Memo

To: 82C465MV Customers
From: Mark R. Williams, Tech. Mktg. Engineer (408) 486-8412
Subject: 82C465MV Errata

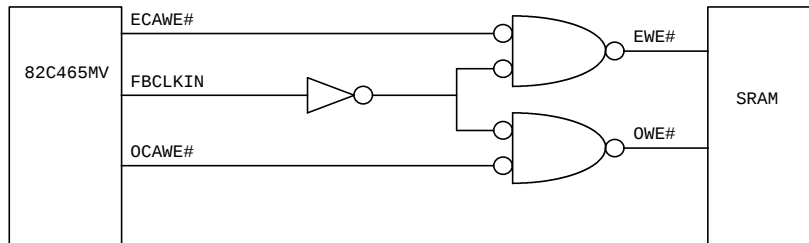
1. DRAM operation is limited to 4-3-3-3 read cycles whenever the L2 cache is enabled. This problem can be corrected in hardware using the scheme below that reduces the active time of the ECAWE# and OCAWE# signals to the SRAM. DRAM can be run at 3-2-2-2 when this fix is introduced.
